**City of Portland, Oregon**  
**Bureau of Development Services**  
**Land Use Services**  
FROM CONCEPT TO CONSTRUCTION

**DATE:** 1/7/24  
**TO:** LU 18-137963 DZM  
**CC:** Omar Martinez Barrera | Casa Bonita LLC  
**FROM:** Puja Bhtani, Land Use Services  
**RE:** Exhibit List for LU 18-145469 HR

The intent of the memo is to clarify the final exhibit list for case file LU 18-145469 HR. The final decision notice mailed on 9/17/18 had the incorrect exhibit list at the end of the decision. Below is the correct exhibit list.

**Date:** September 17, 2018  
**To:** Interested Person  
**From:** Puja Bhutani, Land Use Services  
 503-823-7226 / [Puja.Bhutani@portlandoregon.gov](mailto:Puja.Bhutani@portlandoregon.gov)

**A**  
**1** DORMER SECTION 8:12  
 1/4" = 1'-0"

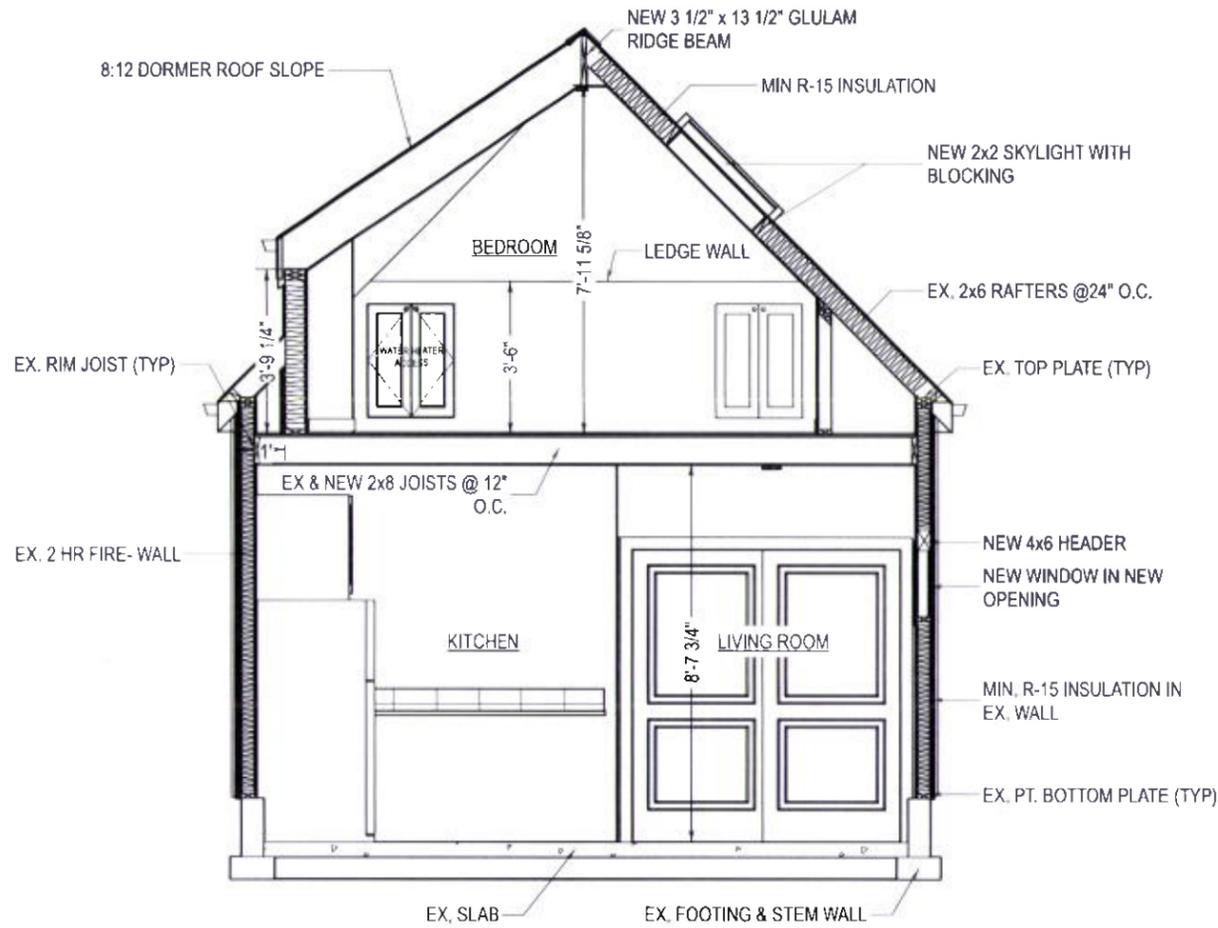
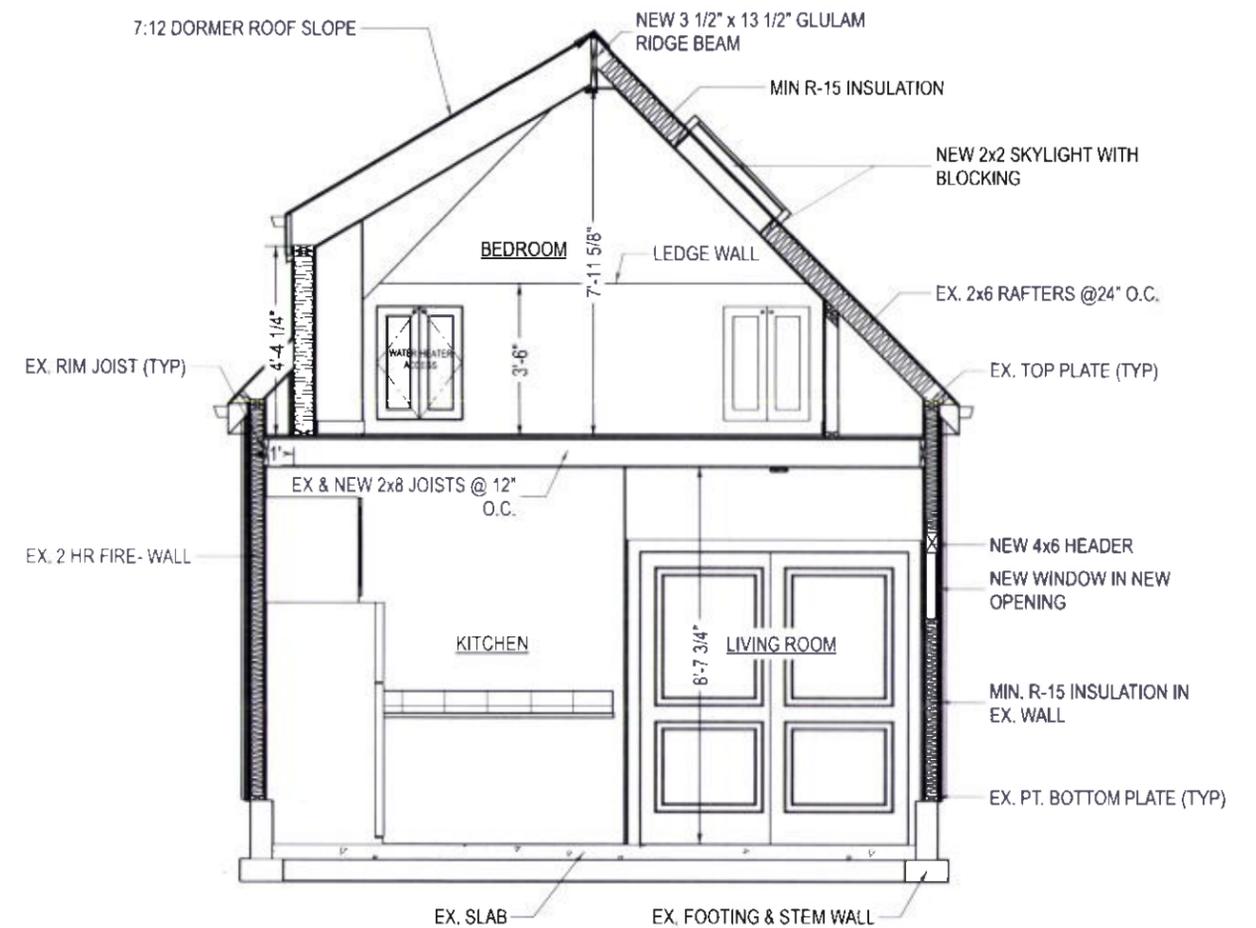
8:12 SHED ROOF DOES NOT ALLOW FOR EGRESS WINDOW. CEILING HEIGHT DOES NOT MEET MINIMUM REQUIREMENT OF 6'-8" COMPRISING AT LEAST 50% OF ROOM AREA. CEILINGS UNDER 5'-0" DO NOT COUNT TOWARDS ROOM AREA.

7:12 SHED ROOF DOES NOT ALLOW FOR EGRESS WINDOW. CEILING HEIGHT DOES NOT MEET MINIMUM REQUIREMENT OF 6'-8" COMPRISING AT LEAST 50% OF ROOM AREA. CEILINGS UNDER 5'-0" DO NOT COUNT TOWARDS ROOM AREA.

**C**  
**1** DORMER SECTION 4:12  
 1/4" = 1'-0"

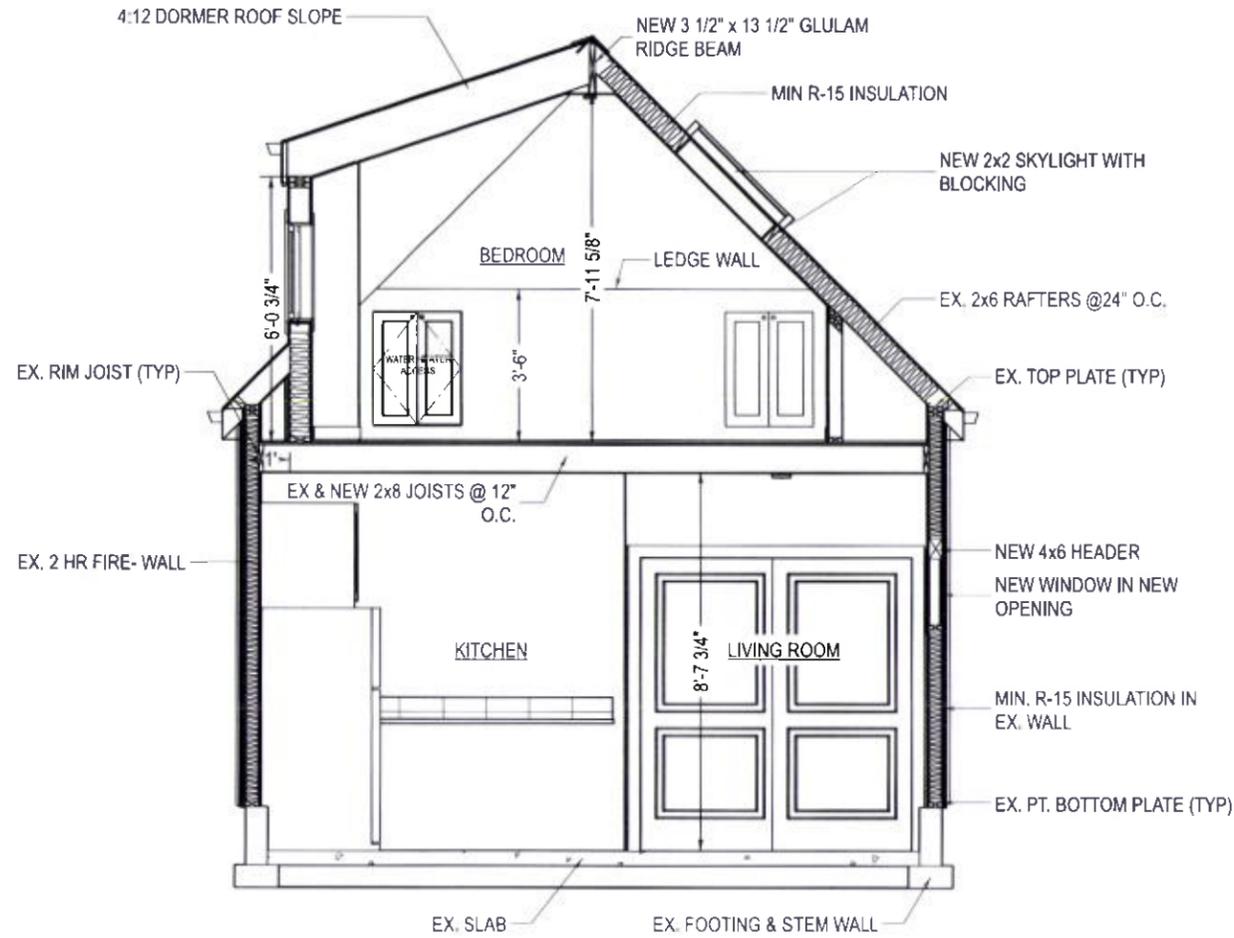
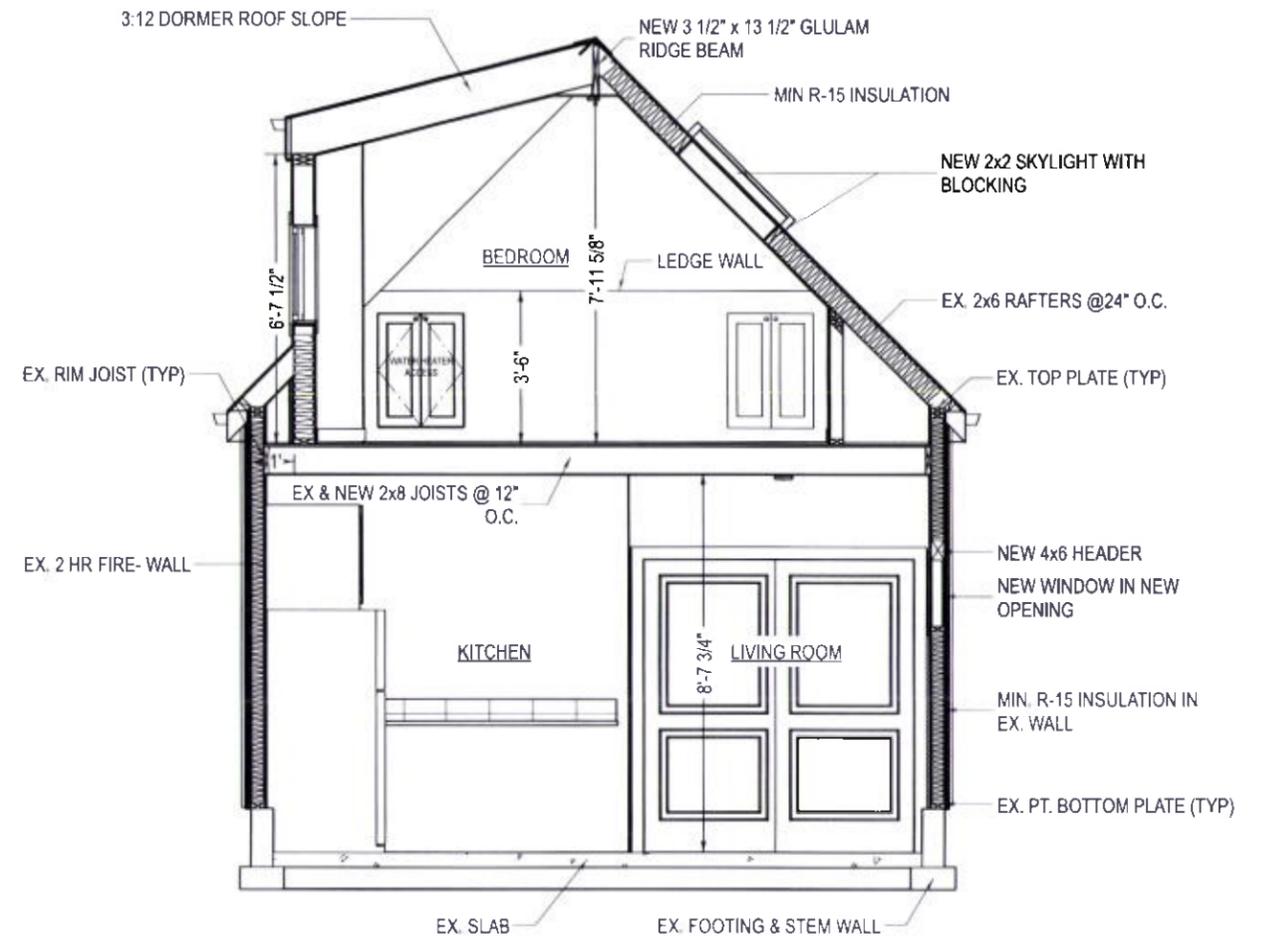
4:12 SHED ROOF DOES ALLOW FOR EGRESS WINDOW.  
 CEILING HEIGHT DOES NOT MEET MINIMUM REQUIREMENT  
 OF 6'-8" COMPRISING AT LEAST 50% OF ROOM AREA.  
 CEILINGS UNDER 5'-0" DO NOT COUNT TOWARDS ROOM  
 AREA.

**C-1**  
**1** DORMER SECTION 4:12  
 1/4" = 1'-0"

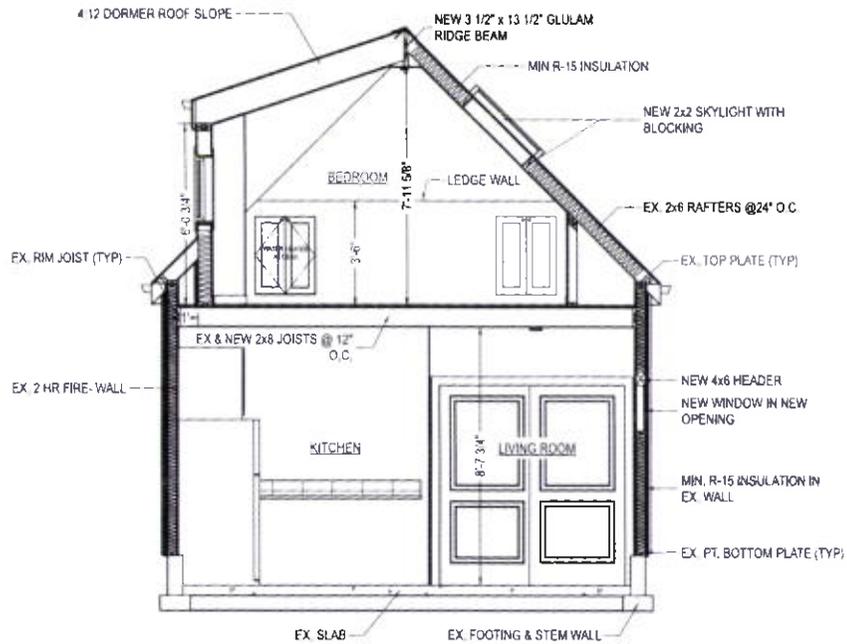
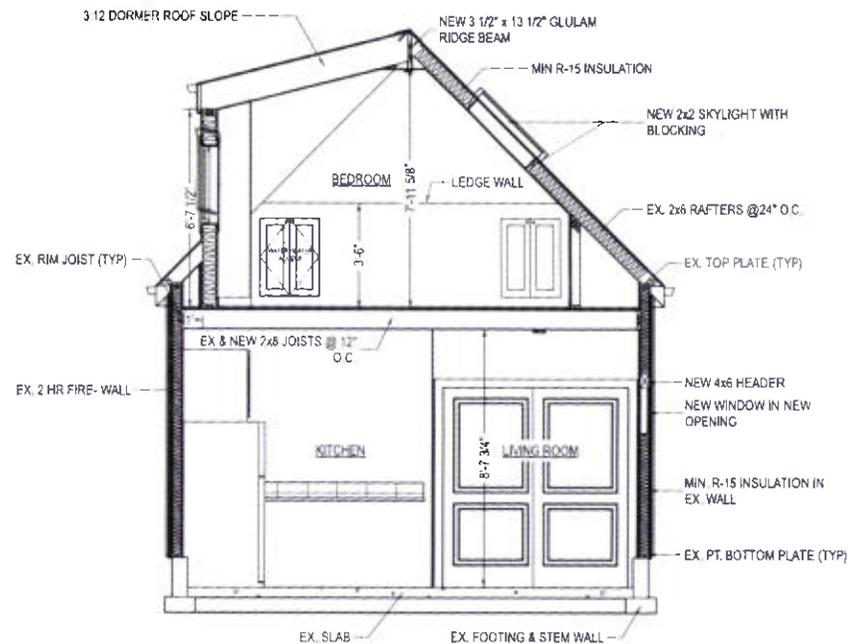
4:12 SHED ROOF DOES ALLOW FOR EGRESS WINDOW.  
 CEILING HEIGHT DOES NOT MEET MINIMUM REQUIREMENT  
 OF 6'-8" COMPRISING AT LEAST 50% OF ROOM AREA.  
 CEILINGS UNDER 5'-0" DO NOT COUNT TOWARDS ROOM  
 AREA.

3:12 SHED ROOF DOES ALLOW FOR EGRESS WINDOW.  
CEILING HEIGHT DOES MEET MINIMUM REQUIREMENT OF  
6'-8" COMPRISING AT LEAST 50% OF ROOM AREA.  
CEILINGS UNDER 5'-0" DO NOT COUNT TOWARDS ROOM  
AREA.

**B-1**  
**1** **DORMER SECTION 6:12**  
 1/4" = 1'-0"

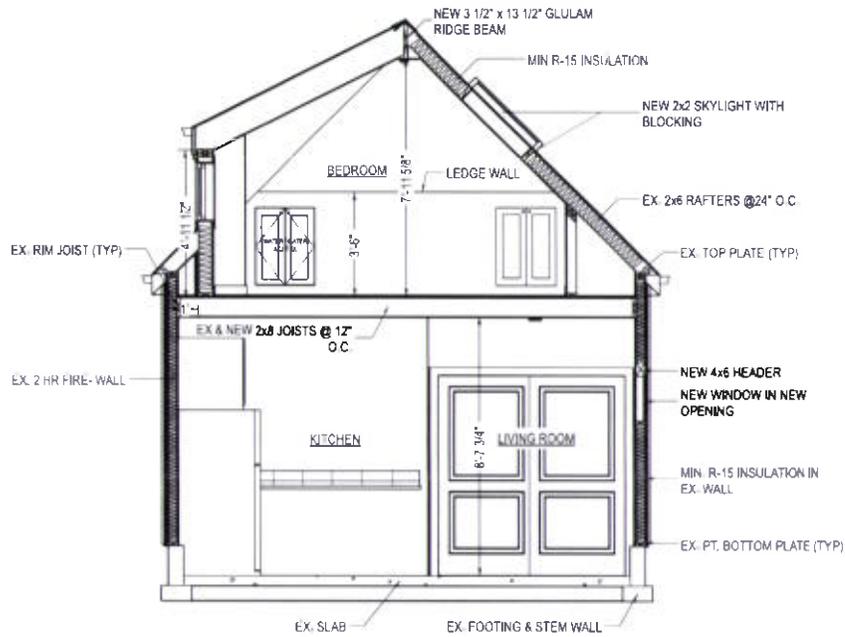
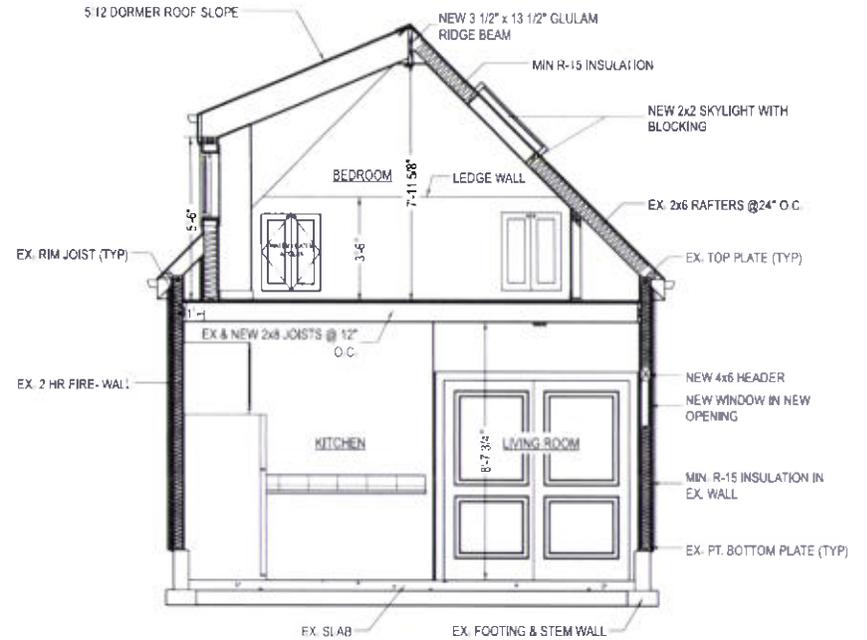
6:12 SHED ROOF MIGHT ALLOW FOR EGRESS WINDOW. CEILING HEIGHT DOES NOT MEET MINIMUM REQUIREMENT OF 6'-8" COMPRISING AT LEAST 50% OF ROOM AREA. CEILINGS UNDER 5'-0" DO NOT COUNT TOWARDS ROOM AREA.

5:12 SHED ROOF DOES ALLOW FOR EGRESS WINDOW.  
CEILING HEIGHT DOES NOT MEET MINIMUM REQUIREMENT  
OF 6'-8" COMPRISING AT LEAST 50% OF ROOM AREA.  
CEILINGS UNDER 5'-0" DO NOT COUNT TOWARDS ROOM  
AREA.

**A-1**  
**1** **DORMER SECTION 8:12**  
 1/4" = 1'-0"

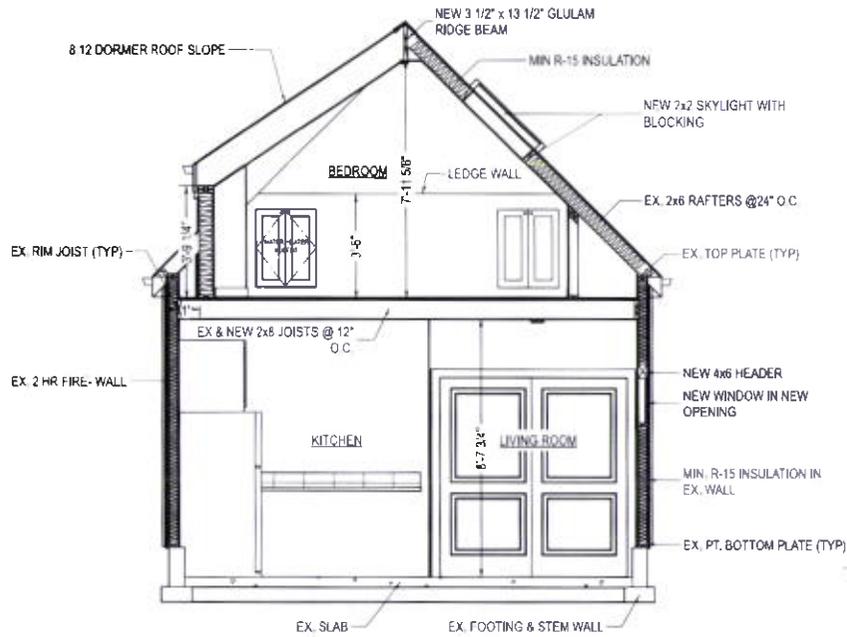
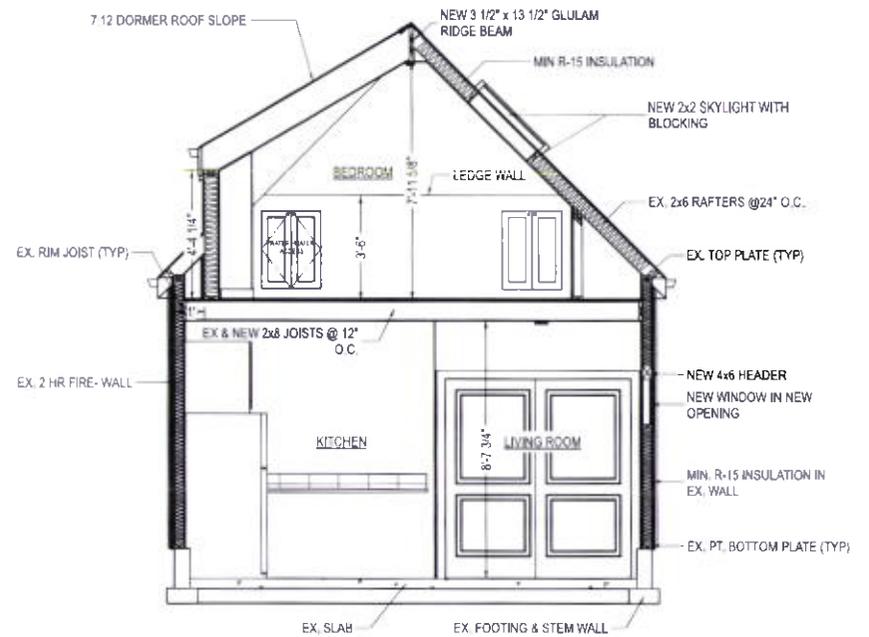
8:12 SHED ROOF DOES NOT ALLOW FOR EGRESS WINDOW, CEILING HEIGHT DOES NOT MEET MINIMUM REQUIREMENT OF 6'-8" COMPRISING AT LEAST 50% OF ROOM AREA. CEILINGS UNDER 5'-0" DO NOT COUNT TOWARDS ROOM AREA.
